STATE OF FLORIDA
DEPARTMENT OF ENVIRONMENTAL PROTECTION

IN RE: CITY OF LAKELAND;)	
C.D. McINTOSH POWER PLANT)	
UNIT NO. 3; MODIFICATION OF)	OGC NO. 93-3123
CONDITIONS OF CERTIFICATION)	
PA-74-06SR-E)	
_____)

FINAL ORDER MODIFYING
CONDITIONS OF CERTIFICATION

PERCENT (%) SULFUR COAL VS PERCENT (%) SO2 REMOVAL - 1994

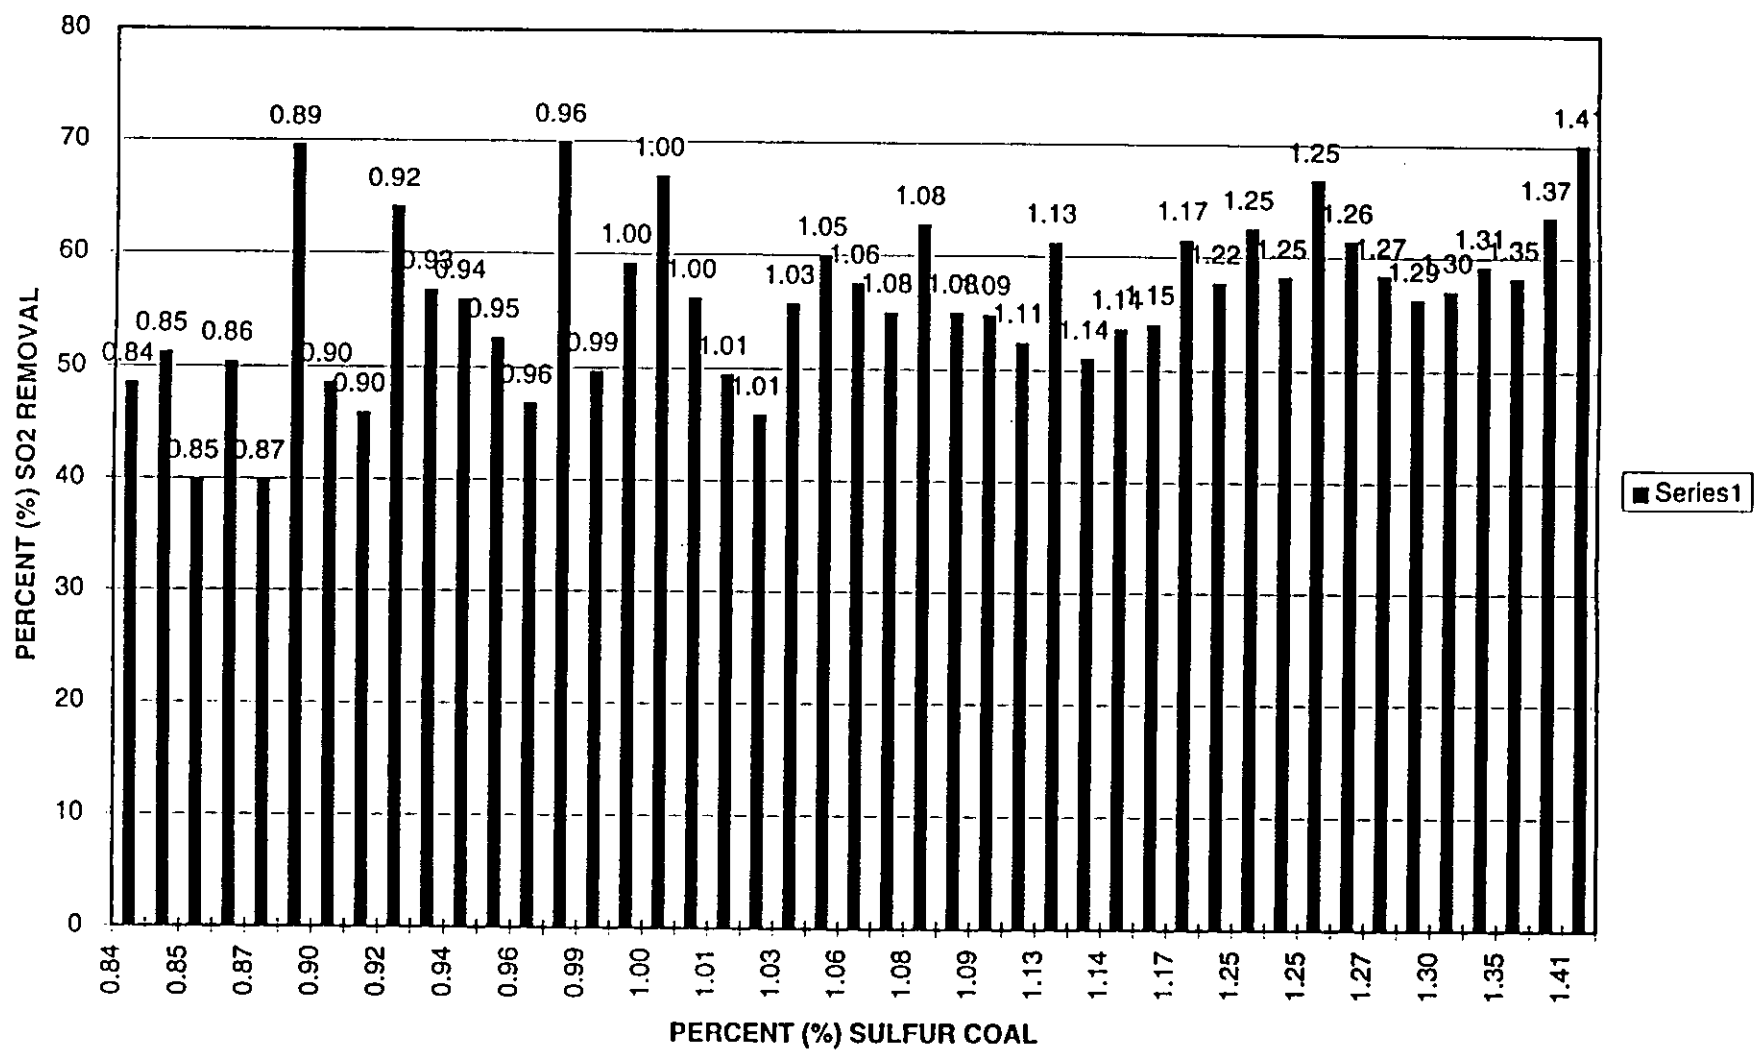
Specifically, the City of Lakeland respectfully requests that specific condition 2.B. be revised to clarify that the 85 percent sulfur dioxide removal efficiency for the flue gas desulfurization system applies only when 3.3 percent sulfur coal is burned. The permit, which was issued by the U.S. Environmental Protection Agency (EPA), states that the flue gas desulfurization system "will operate at a minimum SO₂ removal efficiency of 85 percent." This condition contemplated that high sulfur coal would be used. Both the Site Certification and PSD permit applications stated the sulfur dioxide emissions were based on a 3.3 percent sulfur content of the coal and an 80 percent efficiency rating for the sulfur dioxide scrubber.

The proposed minimum removal efficiency of 55 percent and sulfur dioxide emissions of 0.9 lb/mmBtu will ensure that the scrubber is operated effectively and that the corresponding sulfur dioxide emissions are equivalent to the situation where 3.3 percent sulfur coal is fired with 85 percent removal efficiency. For example, the maximum potential uncontrolled sulfur dioxide emissions for high sulfur coal would be 5.74 lb/mmBtu (3.3% sulfur coal/100 x 2lbSO₂ x 1/11,500 Btu/lb x 10⁶ Btu/mmBtu). At a flue gas desulfurization control efficiency of 85 percent, the controlled emission rate would be 0.9 lb/mmBtu [(1-85%/100) x 5.74 lb/mmBtu]. By requiring that sulfur dioxide emissions not exceed 0.9 lb/mmBtu when coal with a sulfur content below 3.3 percent is fired, the City will be ensuring that the sulfur dioxide emissions are no greater than when high sulfur coal is fired with a control efficiency of 85 percent. This emission rate is consistent with what was originally contemplated during the permit review process (85% SO₂ removal with 3.3% sulfur coal at 11,500 Btu/lb). Since the permit currently allows sulfur dioxide emissions up to 1.2 lb/mmBtu with 85 percent sulfur dioxide removal, an emission rate of 0.9 lb/mmBtu is appropriate as the limit for sulfur dioxide removal efficiencies less than 85 percent.

The proposed 55 percent minimum removal efficiency, which will ensure proper operation of the flue gas desulfurization system, is based on a ratio of the maximum potential sulfur dioxide emissions allowed by NSPS Subpart Da and the 85 percent control efficiency established in the original permit. As you know, NSPS Subpart Da requires 90 percent removal, while the PSD permit for McIntosh Unit No. 3 requires 85 percent removal (both with sulfur dioxide limits of 1.2 lb/mmBtu). With 90 percent removal, the resultant emissions are a unit of 0.10, and with 85 percent removal, the resultant emissions are a unit of 0.15--a difference of 50 percent. NSPS Subpart Da also provides that when emissions are 0.6 lb/mmBtu or less, 70 percent removal is required. With 70 percent removal, the resultant emissions are a unit of 0.30.

A flue gas desulfurization system will be designed to treat all exhaust gases, and The FGD system will operate at: (1) a minimum SO₂ removal efficiency of 85 percent whenever high sulfur (i.e., 3.3 percent or greater) coal is burned, or (2) a minimum of 55 percent SO₂ removal efficiency when the SO₂ emissions are 0.9 lb/mmBtu or less. The sulfur dioxide emissions from the unit shall not exceed 0.9 lb/mmBtu based on a 30-day rolling average.
